Our Ref : Cochlear Response to Submissions

SMEATON GRANGE SOFT DRINK MANUFACTURING PROJECT (08_0011)

TABLE 1 - SUMMARY OF TRAFFIC AND PARKING RELATED AGENCY RESPONSES

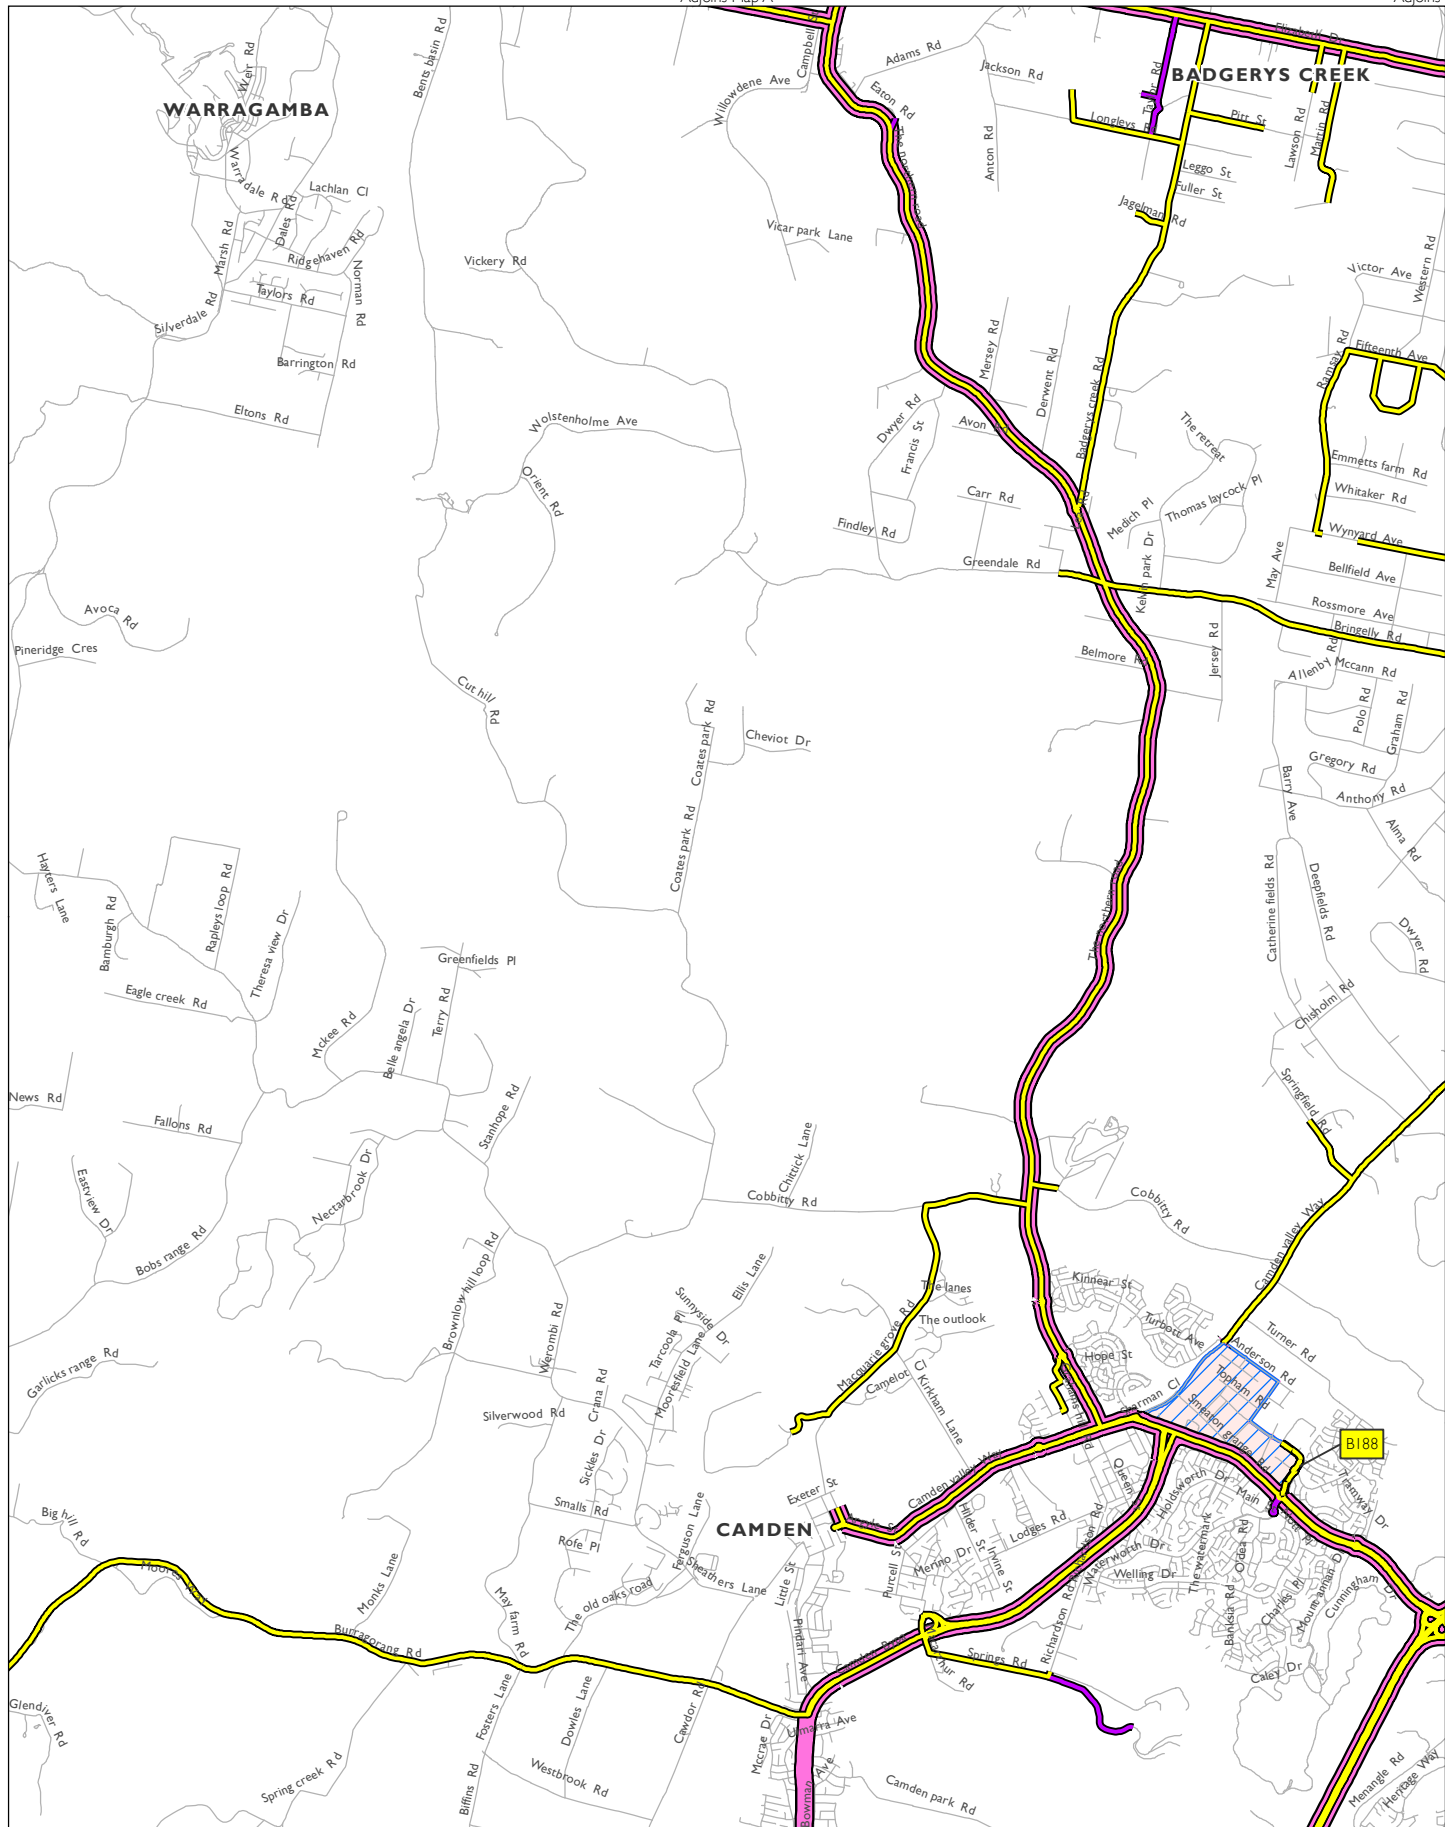
"Please clearly identify the truck route/s that will be used once the facility is operational"

"It should be noted that the existing B-Double route through Smeaton Grange runs North East along Anzac Avenue from Hartley Road and then North West to Camden Valley Way from the Anzac Avenue/Anderson Road roundabout. Any proposed alterations or extensions to this approved route will require the approval of the Roads and Traffic Authority and should be sought. Council would prefer that the existing B-Double route through Smeaton Grange is maintained in its current form. However the extension of the route South West along Anderson Road to the proposed site can be considered."

As noted in the Traffic Report, the water deliveries in the B-Double tanker are advised to come from Moss Vale and hence would most likely use the following general route:

- Hume Highway, between Aylmerton and Narellan Road;
- Narellan Road, between the Hume Highway and Smeaton Grange Road; and
- Hartley Road, Anzac Avenue, Anderson Road and Bluett Drive within Smeaton Grange.

The RTA Travel restrictions Vehicle Routes Sydney E Map is provided on the following page. This shows the majority of Smeaton Grange as being within the B-Double Approved Zones. The P&N site falls outside the zone. Access to the subject site can only be gained by travelling along Anderson Road east of Anzac Avenue and Bluett Drive between Anzac Avenue and the site entrance. **It is recommended that the B-Double Approved Zone be extended to cover these road sections.**
